**PLANNED UNIT DEVELOPMENT  
STAFF REPORT****Date: March 3, 2022**

<b><u>DEVELOPMENT NAME</u></b>	Richardson, Inc.
<b><u>LOCATION</u></b>	1066 Hillcrest Road (Northwest corner of Hillcrest Road and Johnston Lane.)
<b><u>PRESENT ZONING</u></b>	B-2, Neighborhood Business District
<b><u>CITY COUNCIL DISTRICT</u></b>	District 6
<b><u>AREA OF PROPERTY</u></b>	1 Lot / 1.7± Acres
<b><u>CONTEMPLATED USE</u></b>	Planned Unit Development Approval to amend a previously approved Planned Unit Development to allow multiple buildings on a single building site.
<b><u>TIME SCHEDULE FOR DEVELOPMENT</u></b>	Immediately.
<b><u>ENGINEERING COMMENTS</u></b>	<p>ADD THE FOLLOWING NOTES TO THE PUD SITE PLAN:</p> <ol style="list-style-type: none"><li>Any work performed in the existing ROW (right-of-way) such as driveways, sidewalks, utility connections, grading, drainage, irrigation, or landscaping will require a ROW permit from the City of Mobile Engineering Permitting Department (208-6070) and must comply with the City of Mobile Right-of-Way Construction and Administration Ordinance (Mobile City Code, Chapter 57, Article VIII).</li><li>A Land Disturbance Permit application shall be submitted for any prop

# SITE PLAN

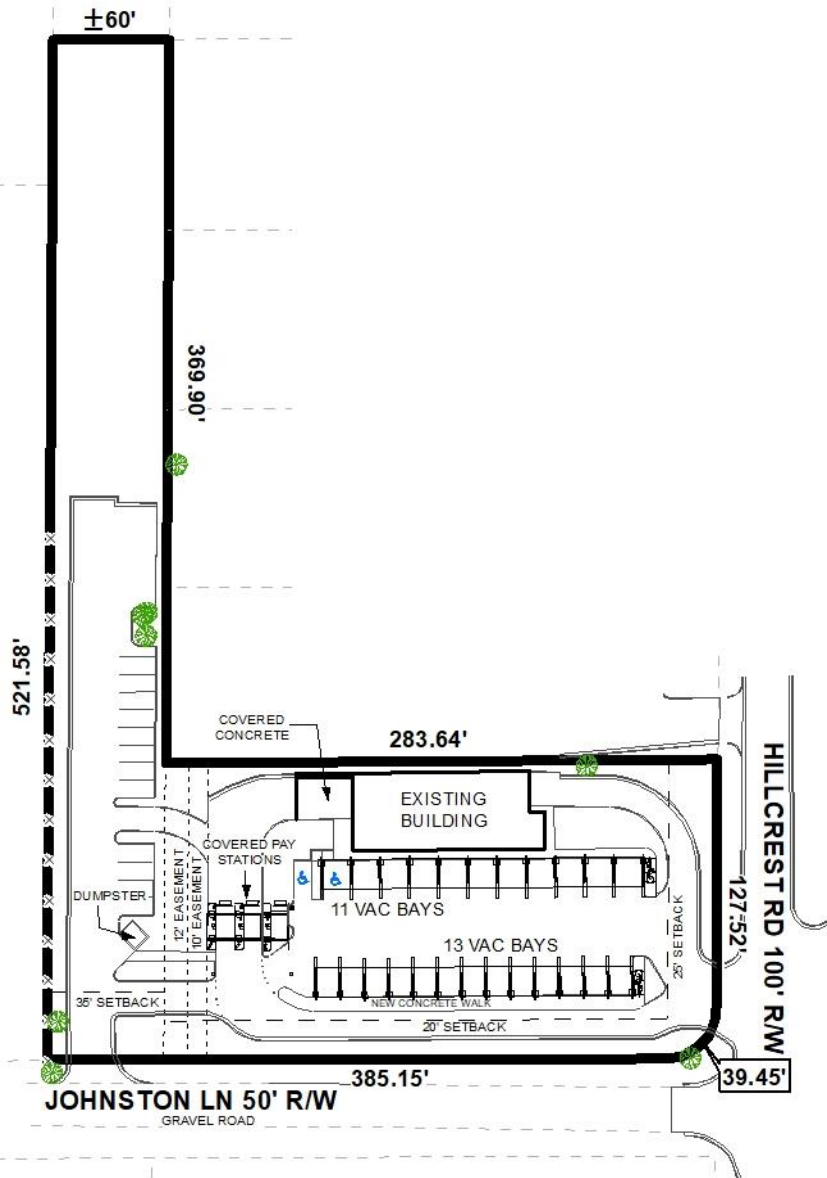
The site plan illustrates a 3,723.9± square-foot building, 1,841.5± square-feet of which is reserved for office use and a customer waiting area, and 1,882.4± square-feet of which is for the automated carwash facility and associated equipment. Twenty-four (24) vacuum bays are also illustrated and, while not depicted, a table on the site plan indicates they will be covered by a 4,912.5± square-foot canopy. As such, seven (7) off-street parking spaces are required, one (1) of which is required to be van accessible. Thirteen (13) parking spaces are illustrated, each of which appear to meet the minimum size requirements of Section 64-6.A.2. of the Zoning Ordinance; and two (2) parking spaces are depicted as van accessible, in compliance with International Building Code (IBC) regulations, one (1) of which serves as a vacuum stall.

Concrete curbing is depicted in both the parking and vacuum stall areas where vehicles could potentially extend beyond the parking lot.

Staff cannot verify the pattern of on-site circulation as no directional signage is depicted on the site plan. Considering there is presumably a mix of one-way and two-way traffic circulation on the site, the plan should be revised to depict the direction of traffic circulation. Furthermore, it appears there may inadequate drive-aisle widths for both one-way and two-way vehicle traffic. The applicant should be aware that drive aisles for two-way traffic circulation are required to be a minimum of 24-feet in width, and the required width of drive aisles for one-way traffic circulation is 14 feet. The plan should, therefore, be revised to depict compliance with these requirements, per Section 64-6.A. of the Zoning Ordinance.

Two-way access to/from the site is proposed along Hillcrest Road and Johnston Lane, the driveways for which are at least 24-feet in width in compliance with Section 64-6.A.2. of the Zoning Ordinance. With respect to access management, a note should be placed on the revised PUD site plan stating the Traffic Engineering comments.

Two (2) covered, drive-thru payment kiosks are proposed and, being electronic, are not required to meet the queuing regulations of the Zoning Ordinance for vehicle stacking from the right-of-way; however, it is unclear how vehicle stacking will occur due to the absence of directional

signage. As such, depending on how traffic will be circulated on site, the applicant may need to revise the site plan to ensure vehicles waiting to enter the carwash do not encroach in any right-of-way.

Due to the proposed amount of parking spaces and vacuum bays, a photometric plan depicting parking lot illumination will be required at the time of permitting. As such, a note should be placed on the revised site plan stating the site will comply with the illumination standards of Section 64-6.A.8. of the Zoning Ordinance and illustrated on a photometric plan submitted for review at the time of permitting.

Landscaping calculations for the site are provided and depict the minimum landscape area requirements of Section 64-4.E.3.a.(1). of the Zoning Ordinance, with the exception of required frontage landscape area. Given the size of the site, 5,347± square-feet of landscape area is required between the front property line and the building façade of the principal structure; 4,275± square-feet is proposed. In reviewing the previously approved PUD site plan, the Planning Commission approved 3,2589± square-feet of frontage landscape; thus, approval of the request for reduced frontage landscape area may be appropriate, especially considering more frontage landscaping is proposed than currently exists.

Some tree plantings are illustrated, but do not currently appear to meet the minimum tree planting requirements of Section 64-4.E.3. of the Zoning Ordinance. While tree plantings are not required to be depicted on the PUD site plan, redevelopment of the site requires full compliance with the tree planting requirements of the Zoning Ordinance. As such, a note stating as much should be provided on the revised PUD site plan, and a compliant tree planting/landscape area plan (not including the reduced frontage landscaping percentage) should be submitted for review at the time of permitting. Required frontage tree plantings should be coordinated with staff to insure the trees have sufficient room to grow and thrive.

A dumpster pad is illustrated on the site plan, but it is unclear if it will meet the enclosure and sanitary sewer connection requirements of Section 64-4.D.9. of the Zoning Ordinance. As such, a note should be placed on the revised site plan stating that any dumpster pad constructed on the property shall meet the enclosure and sanitary sewer connection requirements of Section 64-4.D.9. of the Zoning Ordinance. Such compliance shall be illustrated on the site plans required for review of the applicable permits. If curbside waste removal is instead proposed to be utilized, such information should be revised on the applicable site plans accordingly.

A sidewalk is illustrated along Hillcrest Road, but not along Johnston Lane. No Sidewalk Waiver appears to have been approved waiving construction of a sidewalk at this location. It should be noted, however, that no previous development approvals seem to have required construction of a sidewalk along Johnston Lane, perhaps since it is an unimproved roadway surfaced with gravel. Nevertheless, redevelopment of the site will require the construction of a sidewalk; or, the

applicant may request a Sidewalk Waiver from the Planning Commission. If a sidewalk is to be constructed along Johnston Lane, it should be illustrated on the revised site plan.

The site abuts residentially zoned property to the West, thus requiring a protection buffer in the form of a wall, wooden privacy fence, or the inclusion of a screen planting strip in compliance with Section 64-4.D.1. of the Zoning Ordinance. It seems there may be a fence along the West property line, but no note identifies the fence, and the illustration is not depicted in any legend on the site plan. As such, the site plan should be revised to either identify an existing buffer, or illustrate a buffer in compliance with Section 64-4.D.1. of the Zoning Ordinance.

A 12'-wide drainage and utility easement, and a 10'-wide sanitary sewer easement occur on portions of the site. As such, a note should be placed on the revised site plan stating no structures shall be constructed or placed within any easement without permission of the easement holder.

No signage is depicted on the site plan, and no information regarding signage was provided to staff for review. All proposed signage for the site requires separate reviews by, and permits from, the Planning and Zoning Department. Illuminated signage also requires its design and construction to be completed by a licensed and bonded sign contractor, along with additional Electrical Permits from the Permitting Department.

- 1) Placement of a note on the revised site plan stating the carwash facilities will meet the enclosure and screening requirements of Section 64-12 of the Zoning Ordinance;

- 2) Revision of the site plan to depict compliance with the minimum width requirements of Section 64-6.A. of the Zoning Ordinance for one-way and two-way traffic circulation.

- 3) Revision of the site plan to illustrate the direction of on-site traffic circulation;
- 4) Placement of a note on the revised site plan stating the site shall comply with the parking lot lighting requirements of Section 64-6.A.8. of the Zoning Ordinance, and that a photometric plan in compliance with these requirements will be submitted at the time of permitting;

- 5) Placement of a note on the site plan stating that the site will comply, with the exception of frontage landscape area, with the tree planting and landscape area requirements of Section 64-4.E. of the Zoning Ordinance, and that a tree planting and landscape area plan in compliance with these requirements will be submitted at the time of permitting;

- 6) Placement of a note on the revised site plan stating any dumpster placed on the property will meet the enclosure and sanitary sewer requirements of Section 64-4.D.9. of the Zoning Ordinance;

- 7) Revision of the site plan to illustrate a sidewalk along Johnston Lane, or submission of a Sidewalk Waiver for review by the Planning Commission, prior to the approval of any associated permits;

- 8) Revision of the site plan to either identify compliance with the residential buffer requirements of Section 64-4.D.1. of the Zoning Ordinance, or to illustrate a buffer in compliance with these requirements;

- 9) Placement of a note on the revised site plan stating no structures shall be placed within any easement without permission of the easement holder;
- 10) Compliance with Engineering comments: *(ADD THE FOLLOWING NOTES TO THE PUD SITE PLAN: a) Any work performed in the existing ROW (right-of-way) such as driveways, sidewalks, utility connections, grading, drainage, irrigation, or landscaping will require a ROW permit from the City of Mobile Engineering Permitting Department (208-6070) and must comply with the City of Mobile Right-of-Way Construction and Administration Ordinance (Mobile City Code, Chapter 57, Article VIII). b) A Land Disturbance Permit application shall be submitted for any proposed land disturbing activity with the property. A complete set of construction plans including, but not limited to, drainage, utilities, grading, storm water detention systems and paving will need to be included with the Land Disturbance permit. This Permit must be submitted, approved, and issued prior to beginning any of the construction work. c) Any and all proposed land disturbing activity within the property will need to be submitted for review and be in conformance with Mobile City Code, Chapter 17, Storm Water Management and Flood Control); the City of Mobile, Alabama Flood Plain Management Plan (1984); and, the Rules For Erosion and Sedimentation*
